MEMORANDUM

RE: **Spring Hill Village – ZMA 2013-00017 – Variation Request**

FINAL SITE PLAN FOR BLOCKS B - G
SPRING HILL VILLAGE
ALBEMARLE COUNTY, VIRGINIA
APPLICATION/BLOCK PLAN

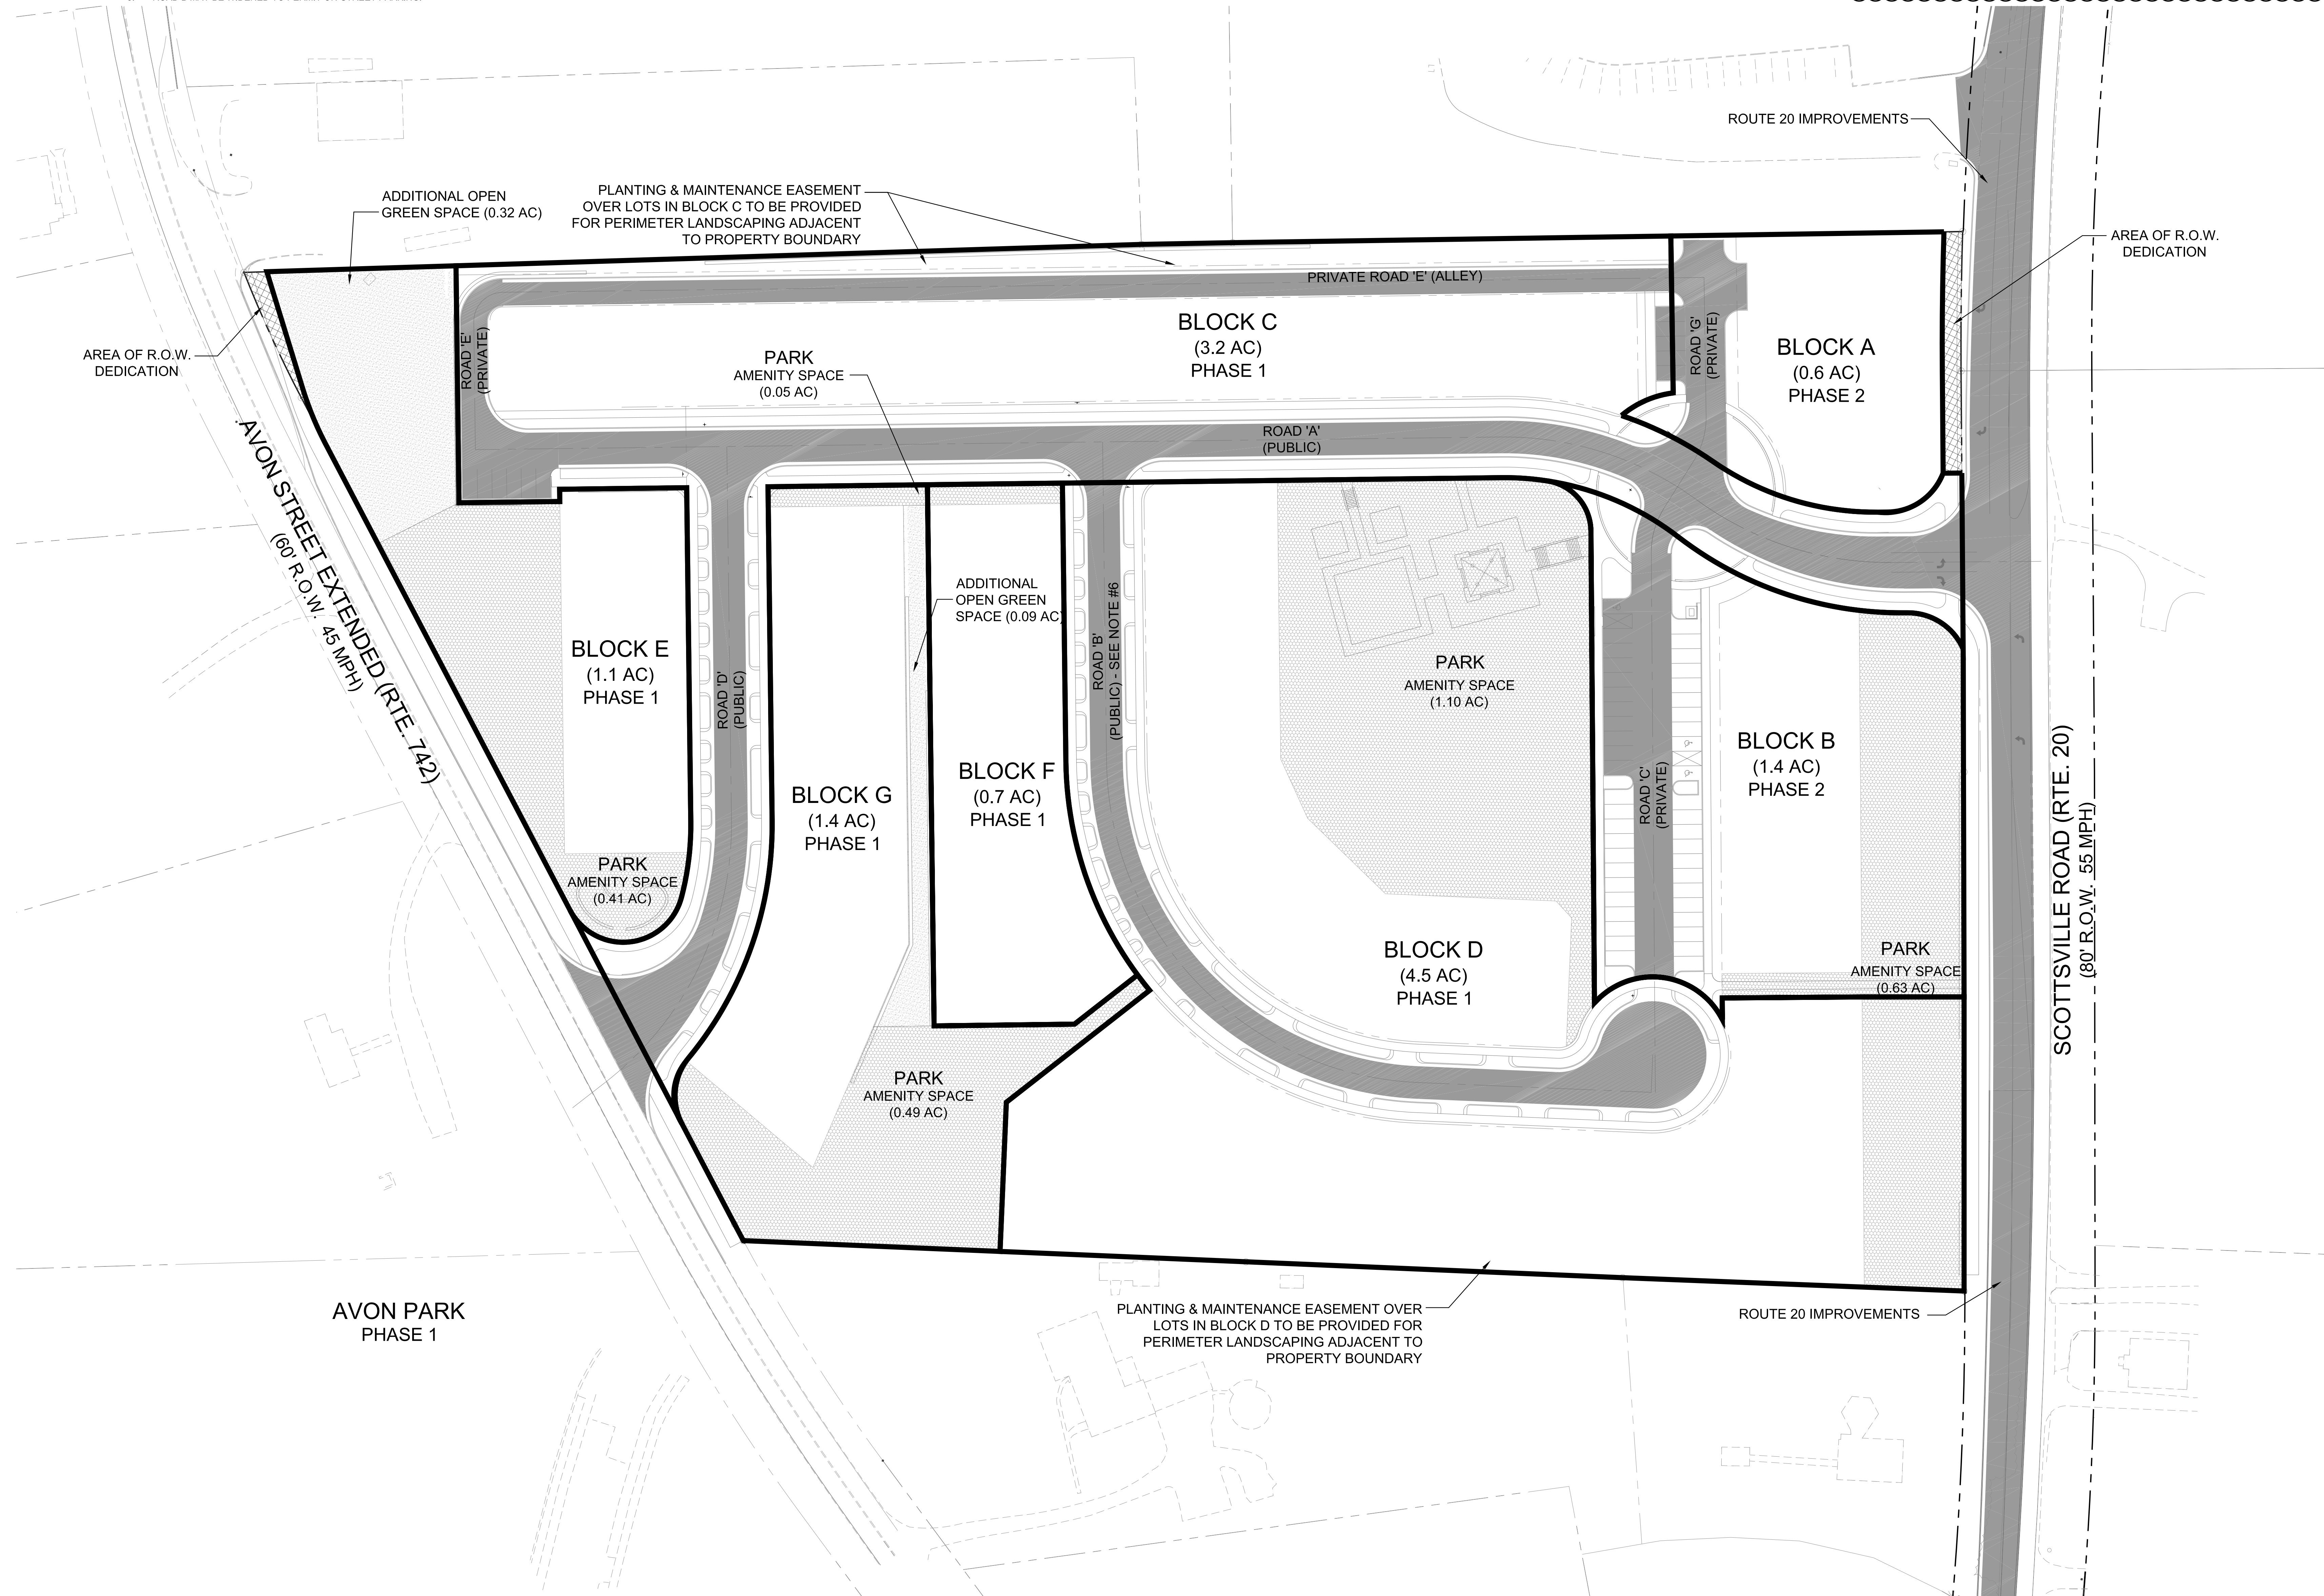
After approval of the rezoning, and as a part of their review of the Initial Site Plan for Phase 1 of this project, VDOT decided to revisit their approval of the planned road system. Numerous iterations and options were explored with VDOT and a consensus was finally reached. The result was that sections of internal road were realigned. This resulted in changes to acreages of adjacent Blocks as well as Green and Amenity Space. All of the acreage impacts were within the ranges permitted by the Code of Development. However, since tables listing these acreages are found on the same drawing (Block Plan-Sheet 3) as the road realignment, these figures were also updated.

Collaterally, several housekeeping matters were addressed. First, in the Density Table at the top right of the Block Plan, Block C had been listed to be in Phase 2. The submitted Initial Site Plan included all of Phase 1 and Block C as well. Staff requested that we change Block C's designation to Phase 1 instead. This was done. Finally, a note was added to the bottom of the Amenity and Green Space Calculations table on this sheet.

VDOT determined that two 90 degree intersections, as opposed to the approved curvilinear main road alignment, would better serve the community in terms of safety and would be more likely to discourage cut-through traffic between Avon Street Extended and Route 20. By and large we were able to accommodate the design changes they requested within the limitations outlined in the approved Code of Development, so we feel that the proposed changes remain consistent with prior approvals and the Code for this property. That said, we did choose to make the above housekeeping changes associated with comments received during initial site plan review at this time.
